Control Number: 35077

INTERCONNECTION AGREEMENT

CED Crane Solar, LLC

FIRST AMENDMENT TO INTERCONNECTION AGREEMENT

Exhibit "C3" Substation Location – TSP Interconnection Facilities

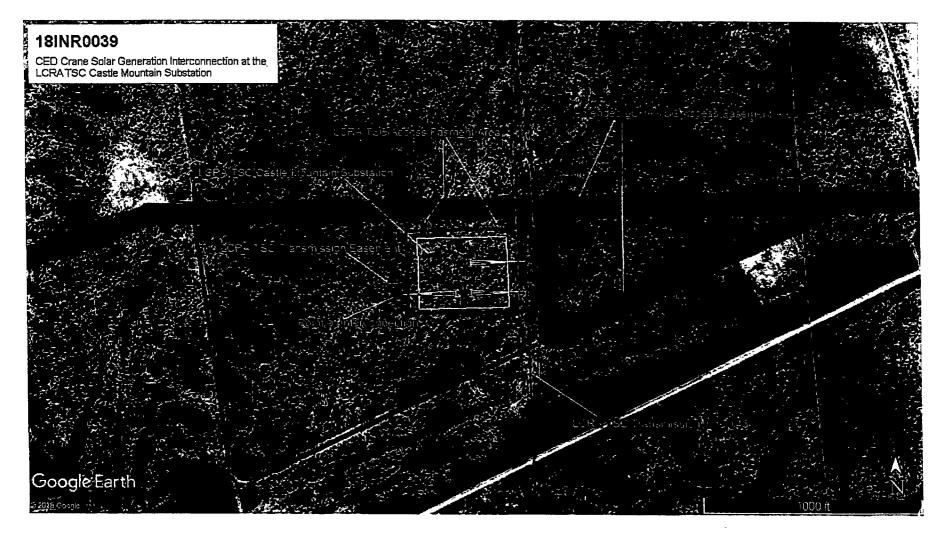
- 1. Exhibits "B", "C", "C3" and "D" are deleted in their entirety and the Exhibits "B", "C", "C3" and "D" attached to this Amendment are hereby added to the Agreement in lieu thereof.
- 2. This Amendment will become effective upon execution by the Parties.

(c) Generator shall also acquire, and convey to TSP, easements that provide good and adequate rights of vehicular ingress and egress to and from the Amended LCRA TSC Access Easement Area to the Substation Site (TSP must approve easement language before completion of landowner negotiation). TSP shall then acquire from the Generator (using TSP's standard form of easement) the access easements generally depicted as the "LCRA TSC Access Easement Area" in Exhibit "C3". (d) Generator shall also acquire, and convey to TSP, a separate stand-alone transmission easement, in a form approved by TSP, including access rights for the portion of the TIF previously described in item 8. D) above and as generally depicted as the "LCRA TSC Transmission Easement" in Exhibit "C3".
